MCPHILLAMYS GOLD PROJECT

Tailings Storage Facility

**Design Review and Response to
submissions received in relation
to the Development Application
and associated EIS**

Report Number: 113272.02R06

Plate 9
TSF Storage Showing Mapped Areas Requiring Lining

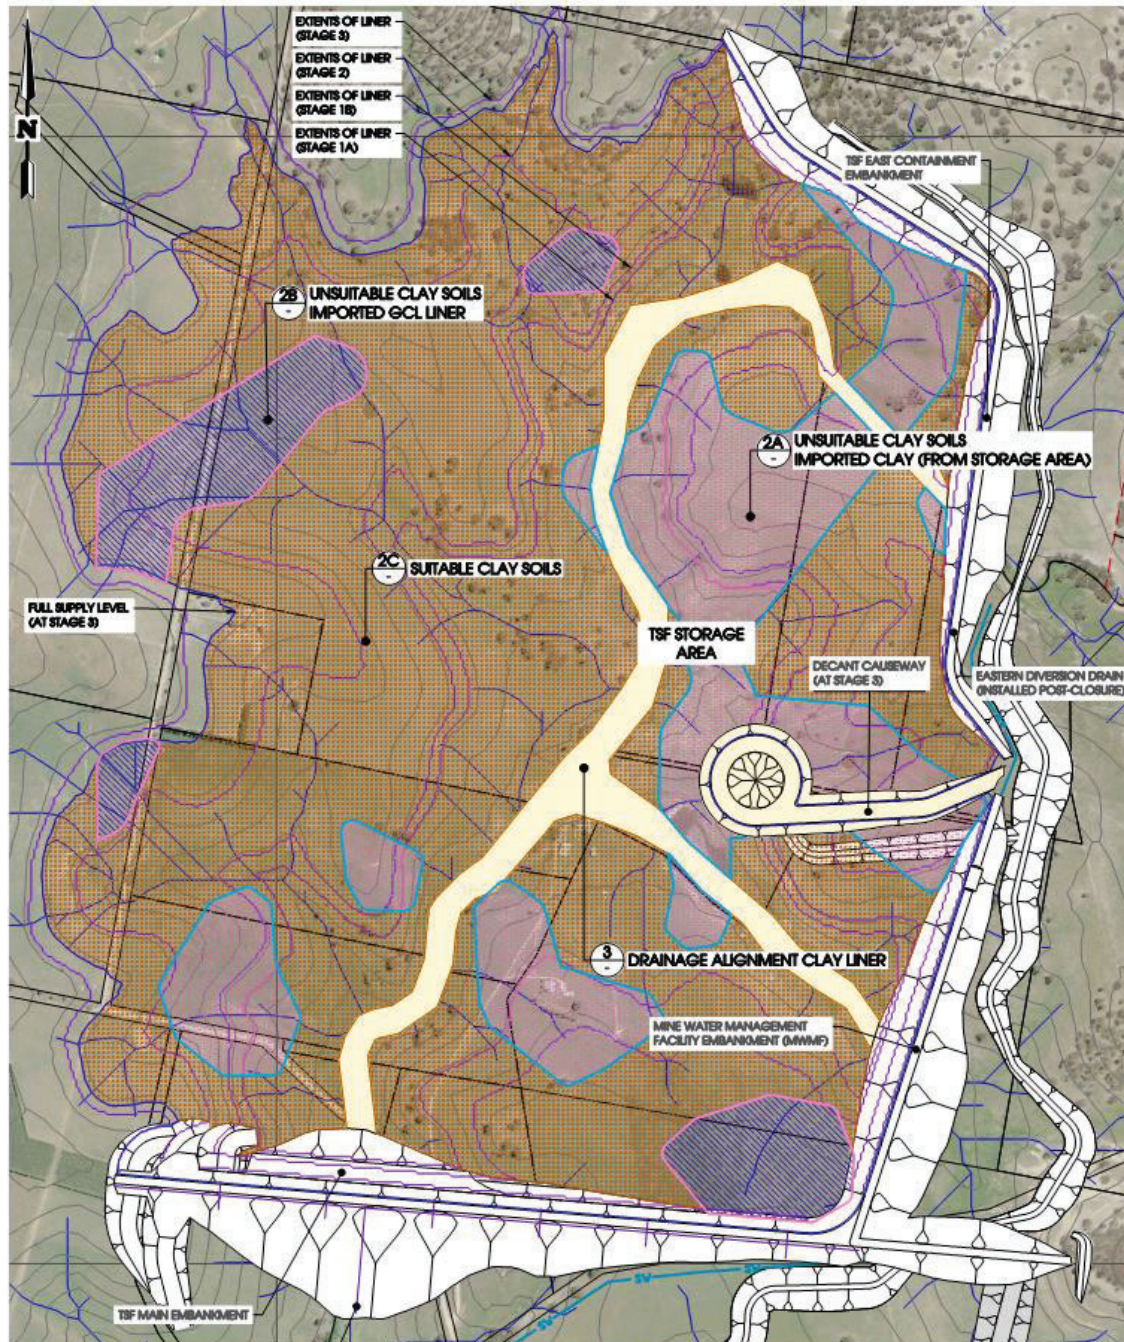
To define the suitable clay zones, the clay thickness map and the clay suitability map were overlain. The resulting map indicates areas that are suitable to provide borrow material as well as zones that would require an artificial lining system, for additional details see attached Drawings. The resulting proposed lining plan is provided in **Plate 9**.

Plate 15
TSF Embankment and Magazine Location

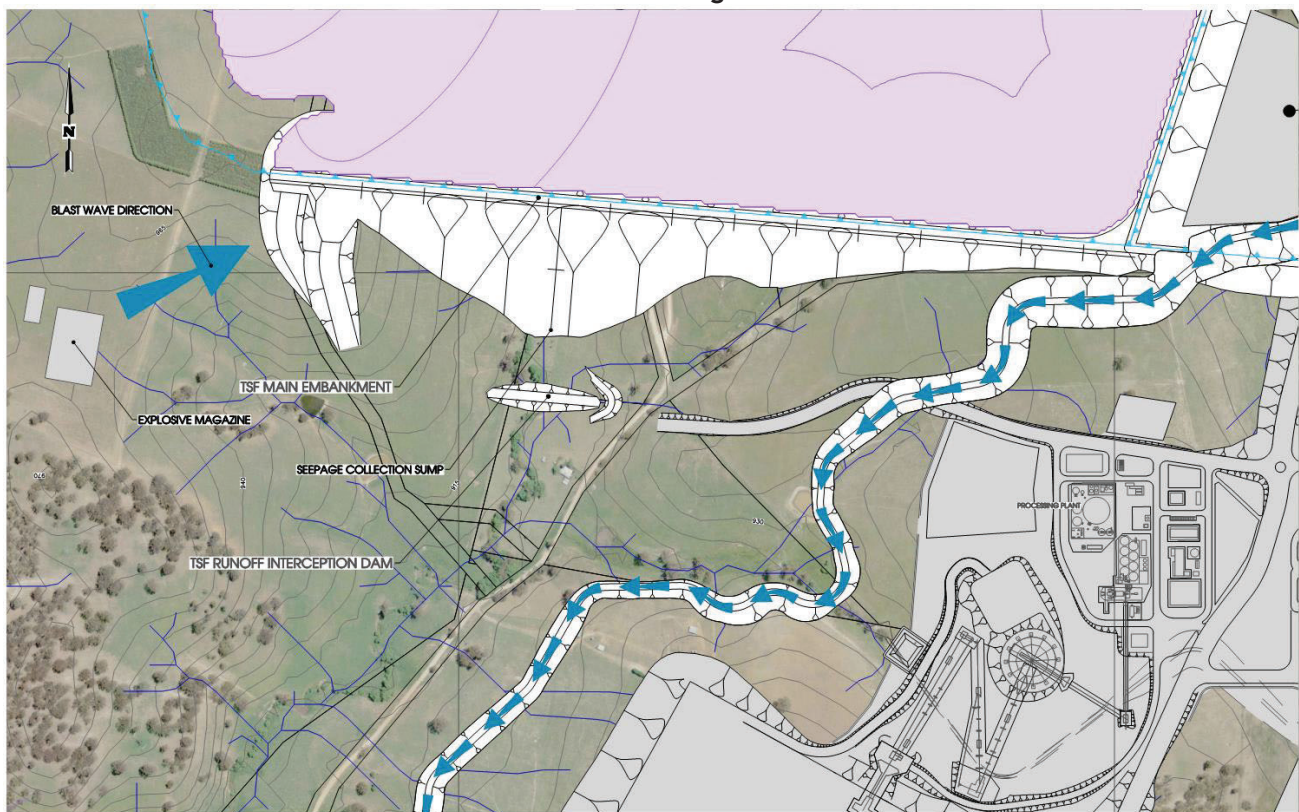
In addition to the stability analyses above, a submission was made in relation to the proximity of the TSF main embankment to the proposed explosives magazine, with this layout shown in **Plate 15**. The key comment is to quantify the impact of the 34 kPa overpressure produced if 288t of AN/ANE explodes, could it impact the current TSF wall. To this end and reference to **Plate 15**, the following simplified assessment is provided:

- The loading of a blast from the Magazine on the TSF embankment would be directed to the downstream face while the upstream side of the embankment will be buttressed by tailings. Forces on the upstream face of the embankment and tailings would be significantly less than isostatic and would not result in movement of the embankment.
- The embankment crest width is a minimum 15m and using a density of 20KN/m^3 and a friction angle of 45 degrees would give a shear strength of 300KPa at 1m depth, i.e., the full supply level. This is significantly greater than the estimated over blast pressure/force of 34Kpa acting on the embankment face.

Plate 16
TSF Post-Closure Landform and Drainage System

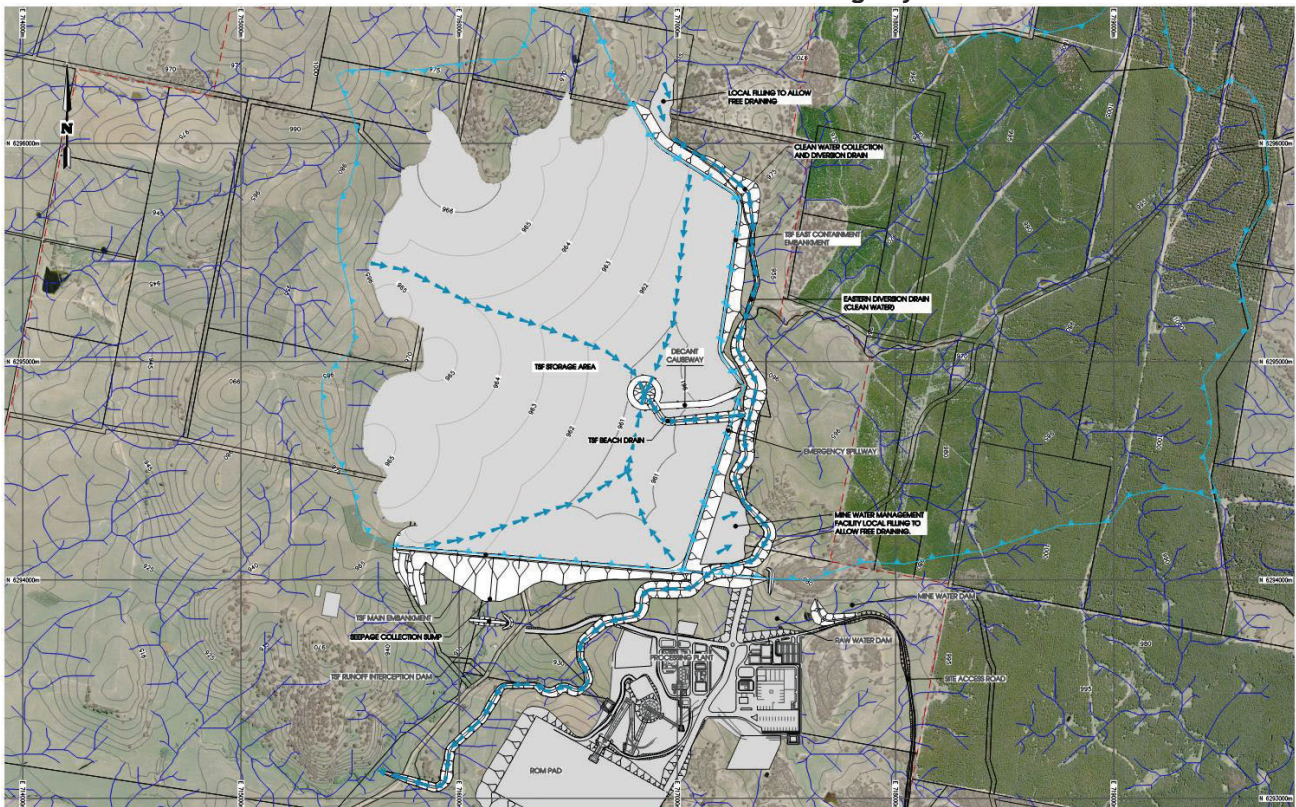
The overall objective of the post-closure tailings beach development will be to allow runoff from the rehabilitated surface to report to the clean water diversion system located on the eastern extent of the TSF as shown in **Plate 16** and detailed in the **Drawings**. It should be noted that this is generally a reversal of the landform drainage to the EIS submission (refer ATCW, 2019). The considered benefits of this change are:

- The post-closure drainage will be more centrally aligned within the catchment, providing greater integration into the surrounding topography.
- The final discharge will be formed to ensure minimise dead storage or ponding areas within the catchment (note that subject to detailed design for closure, some storage areas/dams may be beneficial for post closure land use and would therefore be provided). It will allow the entire catchment to be reinstated post mining, although noting that some storage may be provided as part of the closure plan to use in post-mining land use, i.e., agriculture.
- The grading of the final closure channel will vary from 0.5% to 2% (Refer Drawings).

Plate 21
TSF Seepage Model Results Summary with Sensitivities

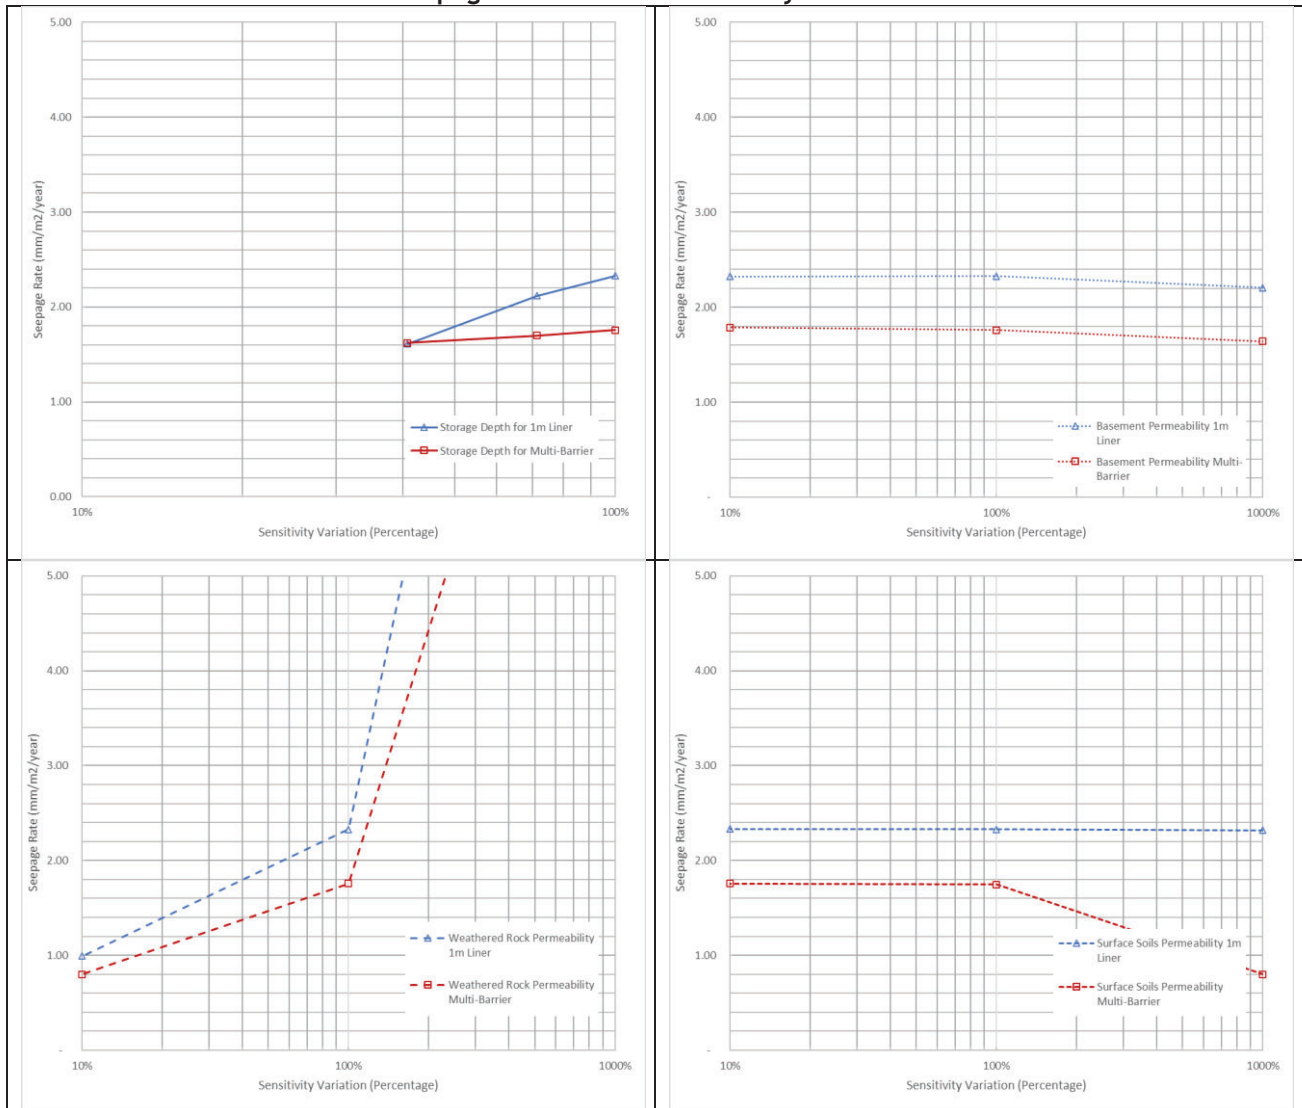
The outcomes have been refined down to present only the proposed multibarrier system and the Solid Waste Landfill Guidelines Liner system. Results are presented as sensitivity results compared to the base case data which used the permeability results as shown in **Table 22**. In addition, the sensitivity of seepage to storage depth is also included for both liner options.

The above results show daily seepage estimates for both the Solid Waste Landfill Management Guideline (1m Clay at 10⁻⁹m/s) and the proposed multi-barrier system. In all cases, the seepage rates reporting downstream of the TSF model were less in the multi-barrier model, although noting that at a storage level of less than 30% of the final proposed TSF height, seepage rates were comparable. The parameter of greatest sensitivity as can be seen above is the permeability of the weathered foundations (i.e. the upper 20m).
